ADDENDUM 2

CSP 22-68

Memorial Middle School Heating & Air Condition (HVAC) Improvements Funded through the Elementary & Secondary Emergency Relief (ESSER) Funds

April 8, 2022

SHEET NUMBER:
M2.11A

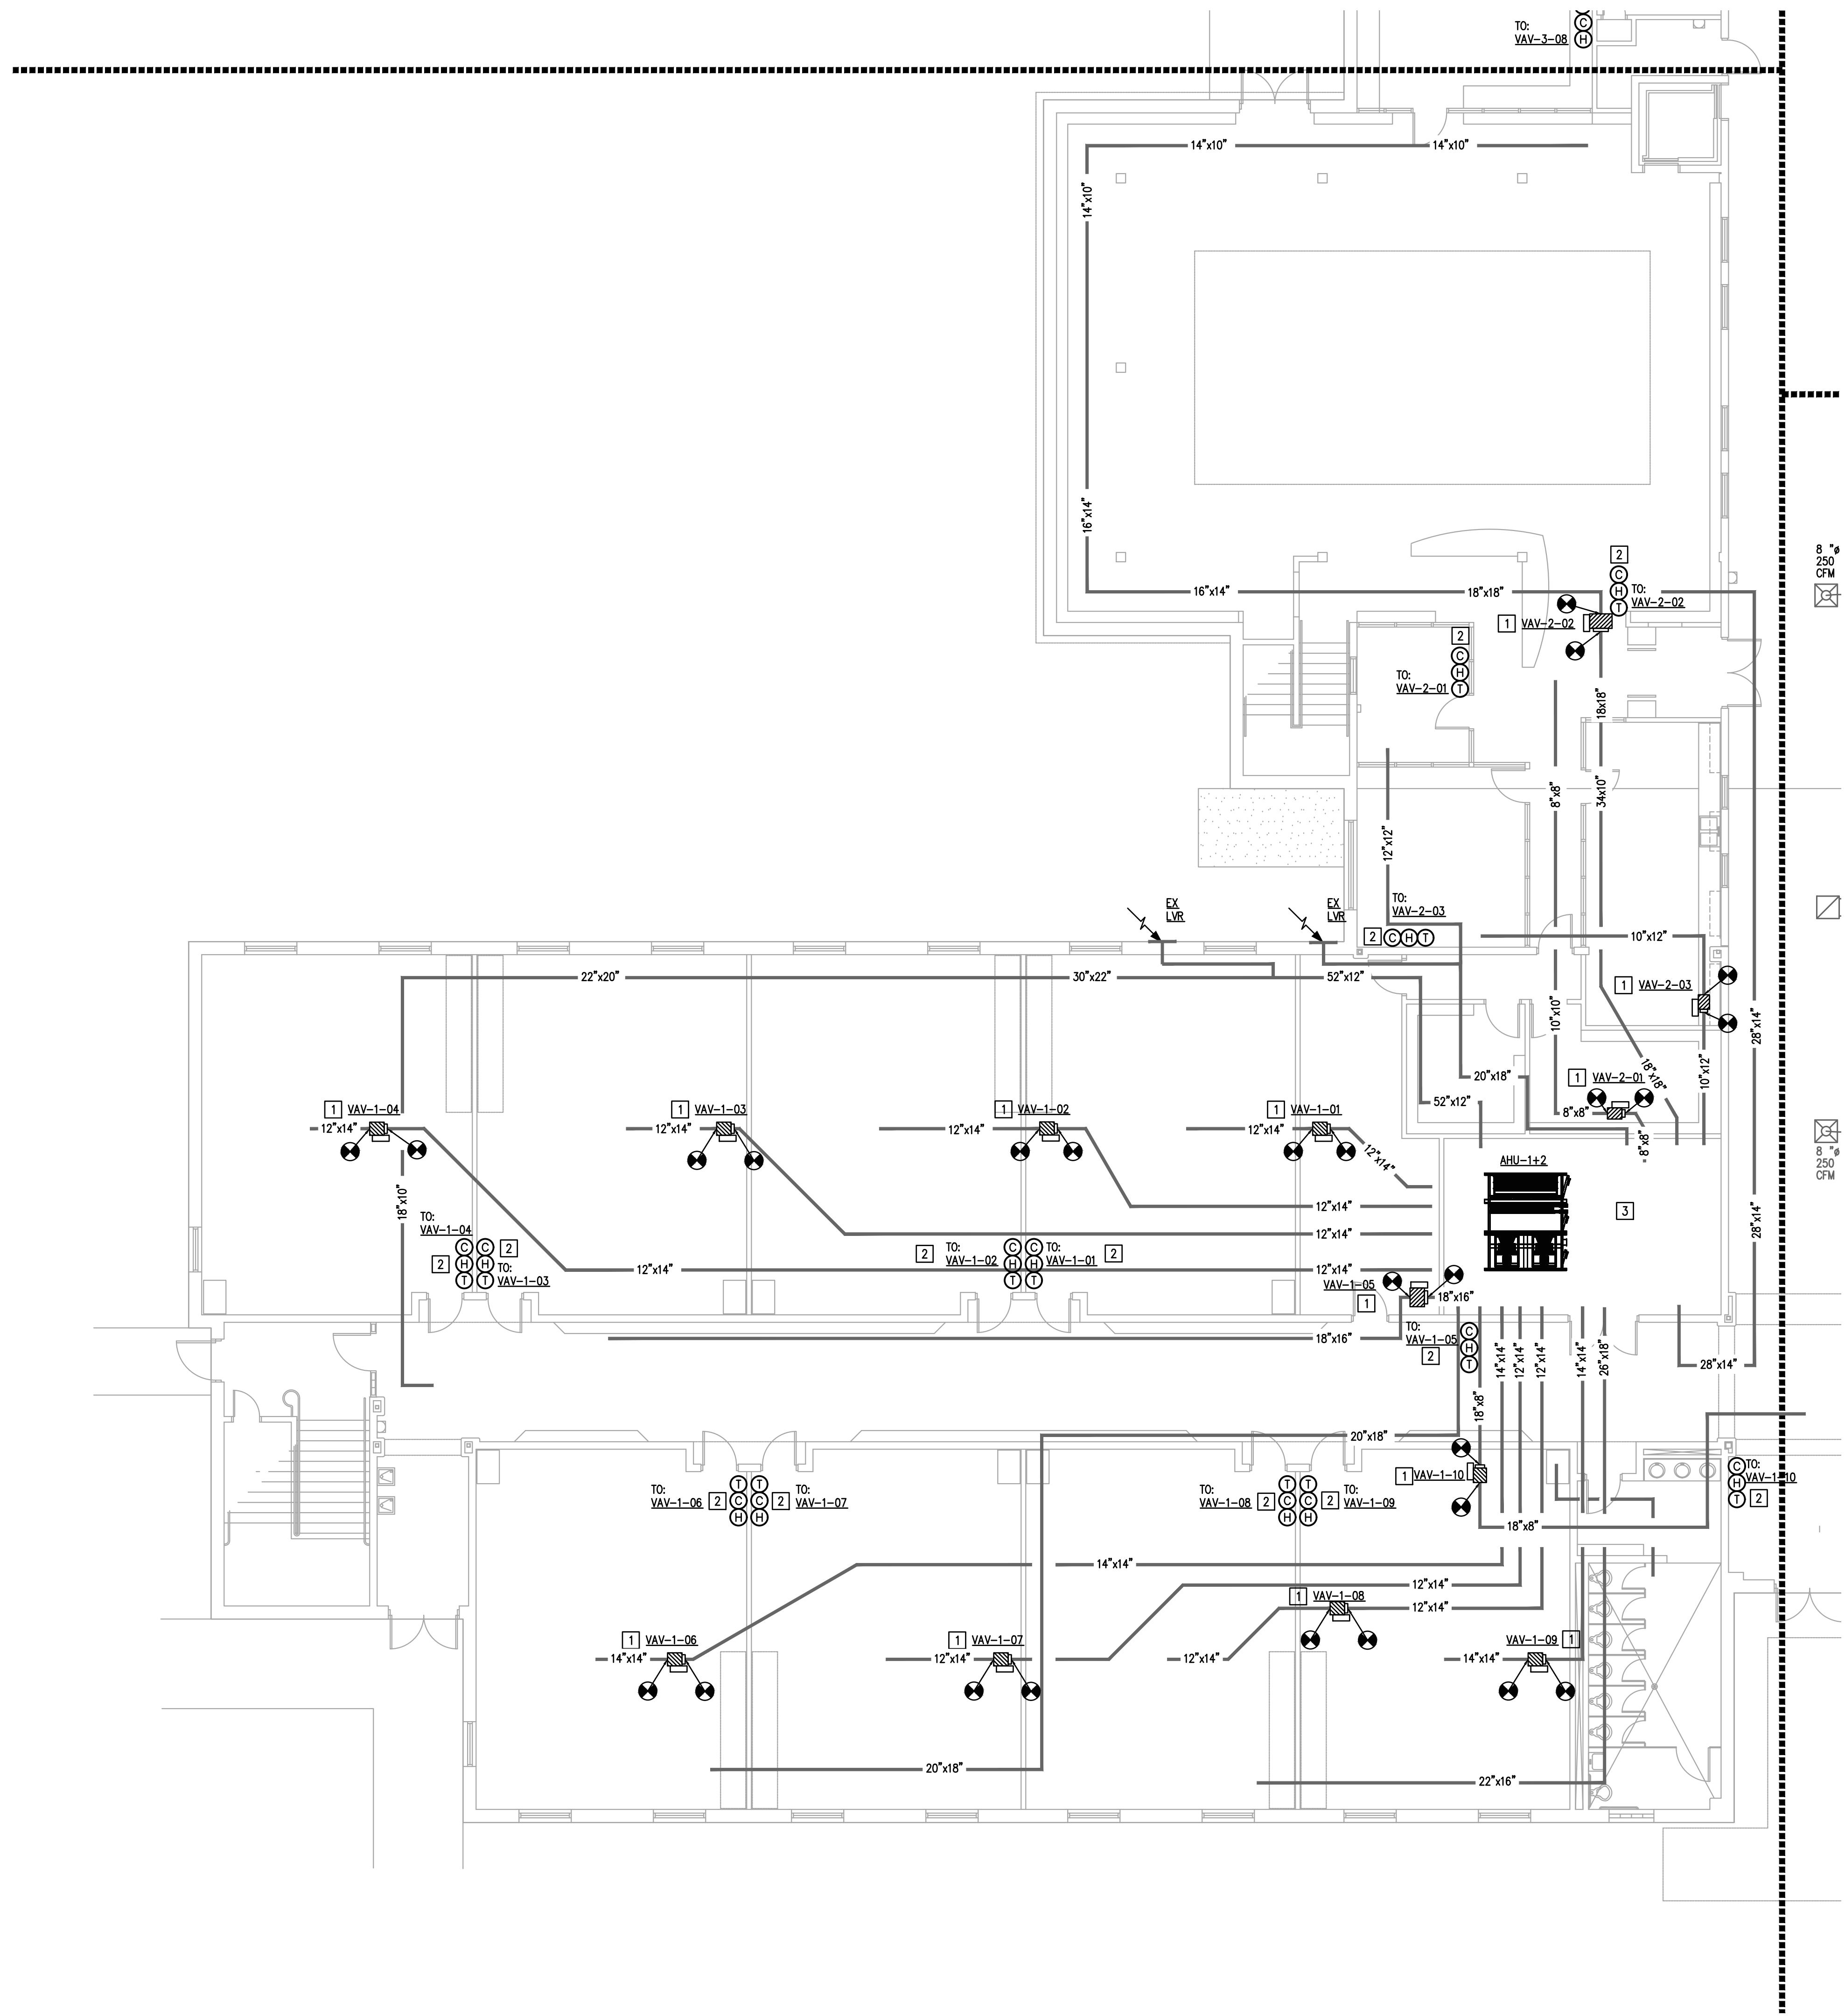
Item 08 SHEET M2.11A – LEVEL 1 MECHANICAL PLAN - A

A. Revised keyed note 1.

M2.11B

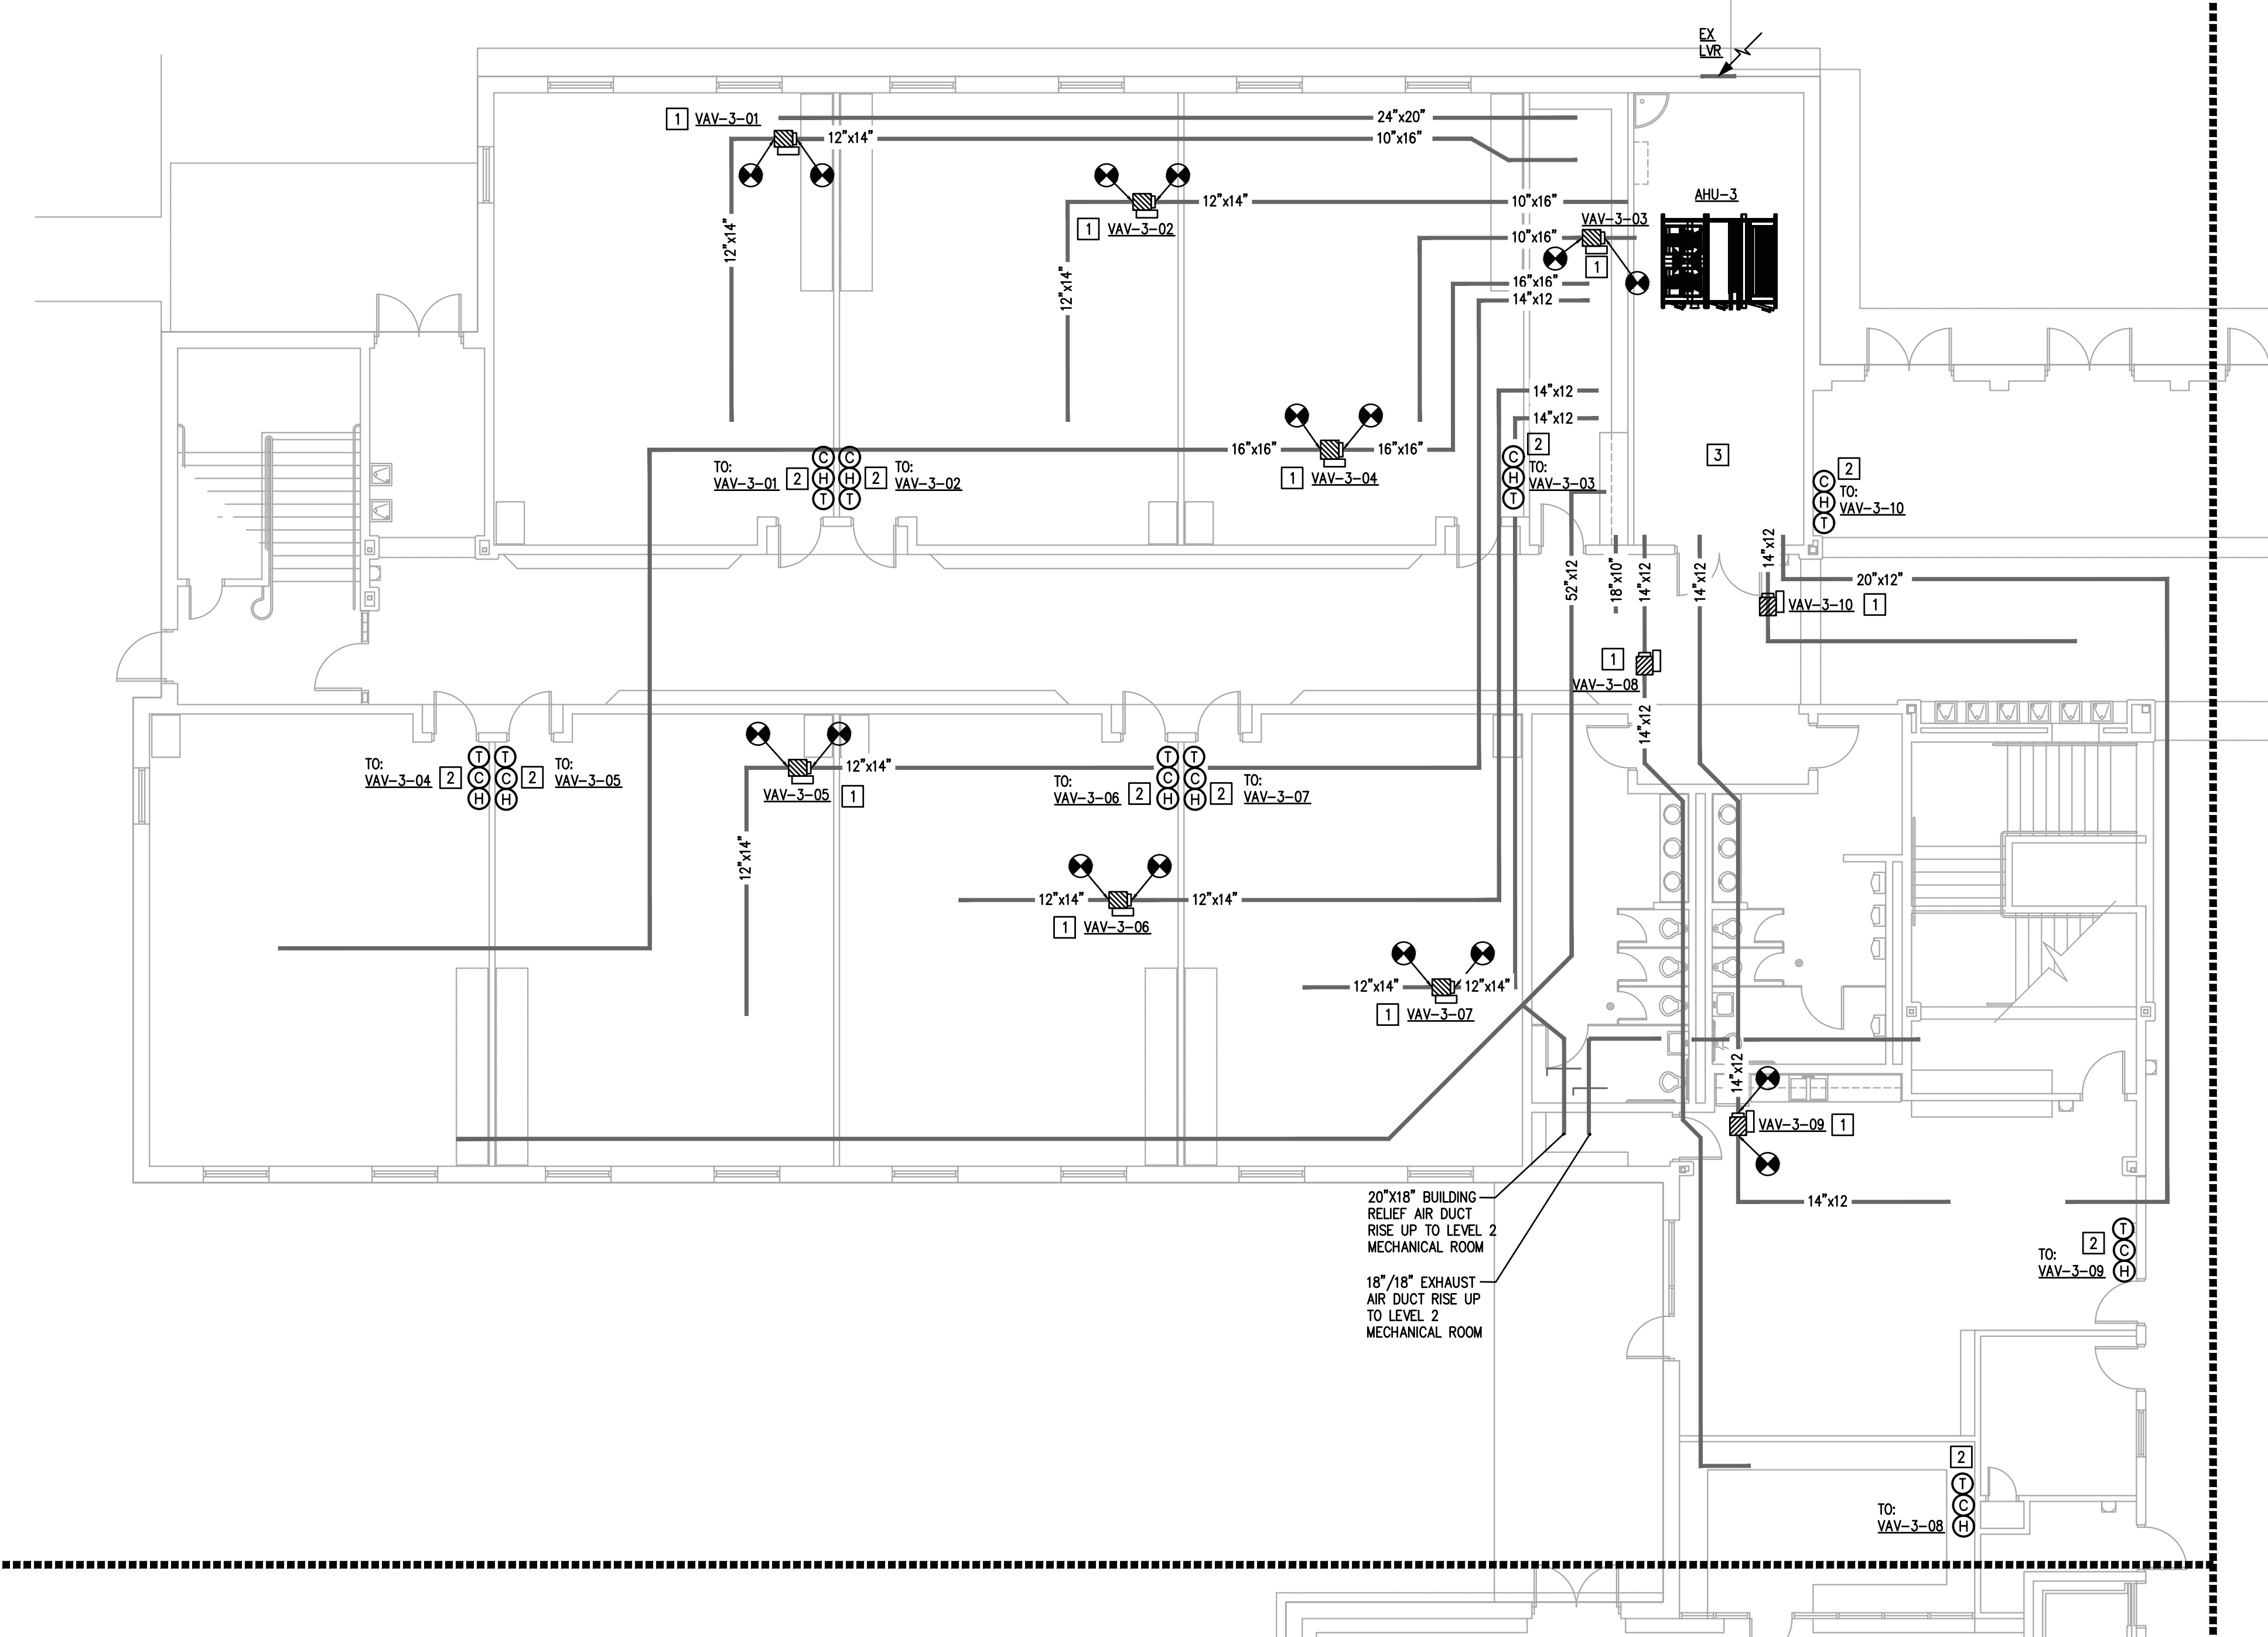
Item 09 SHEET M2.11B – LEVEL 1 MECHANICAL PLAN - B

A. Revised keyed note 1.

M2.11C

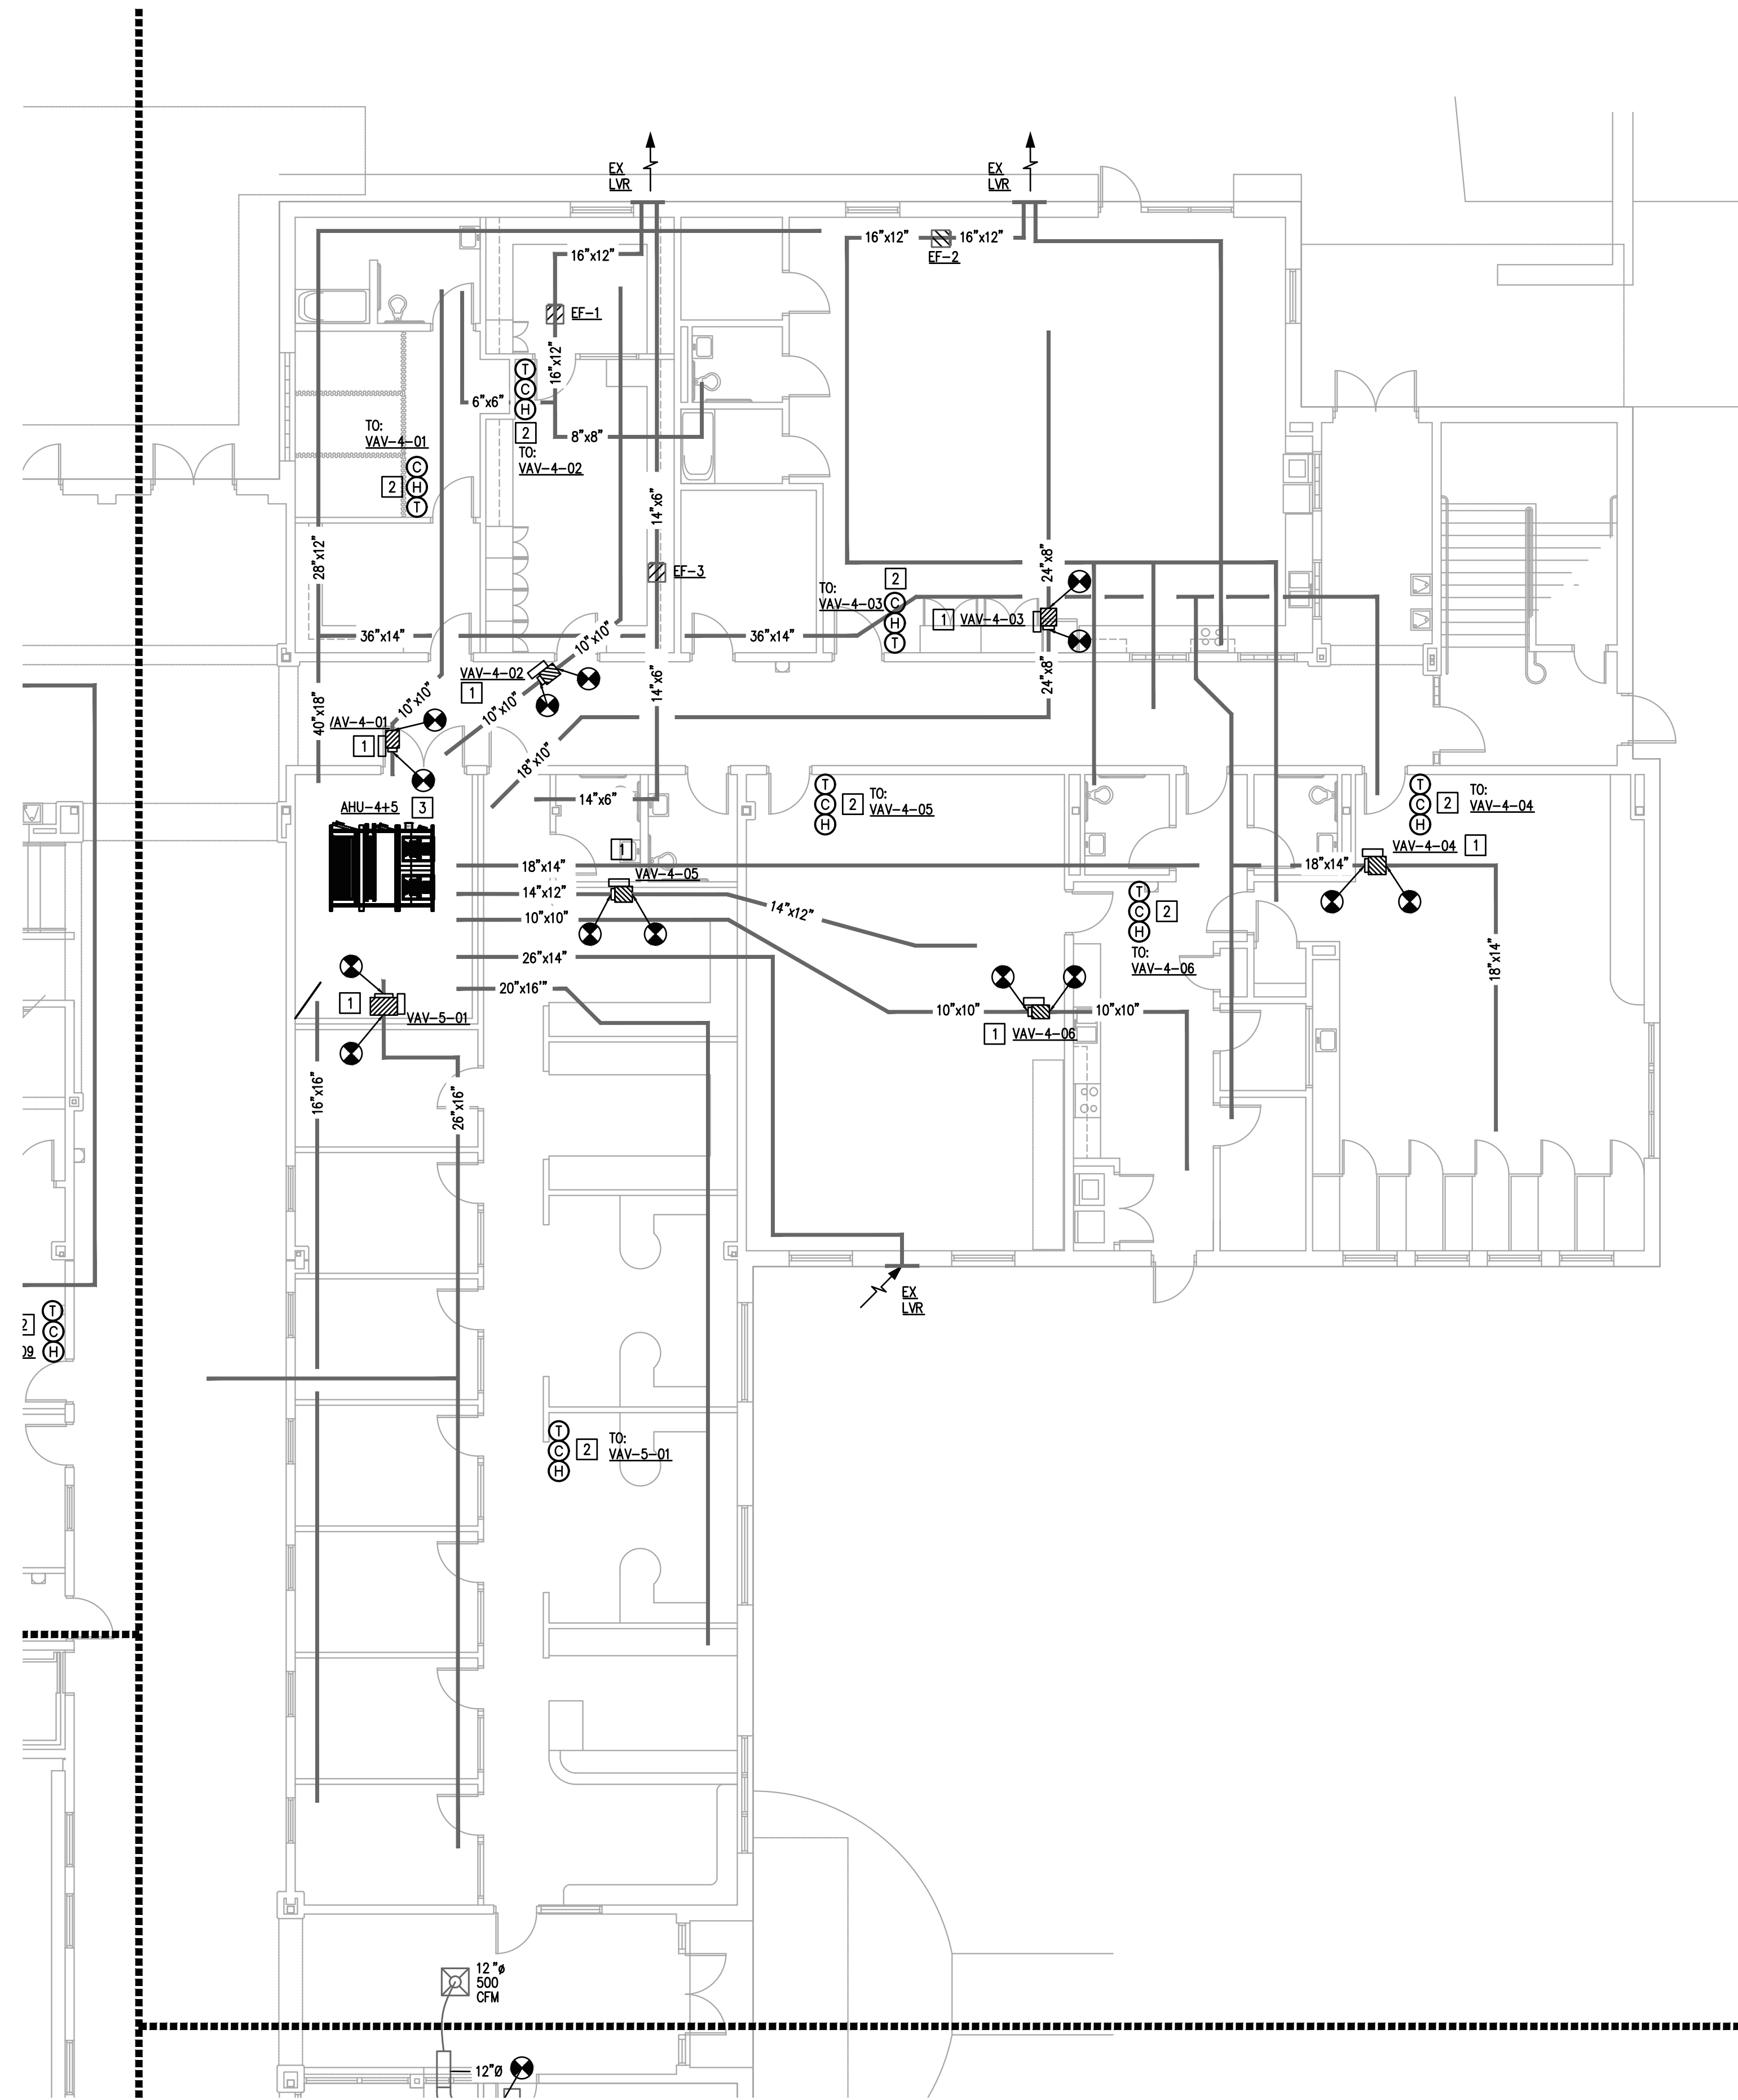
Item 10 SHEET M2.11C – LEVEL 1 MECHANICAL PLAN - C

A. Revised keyed note 1.
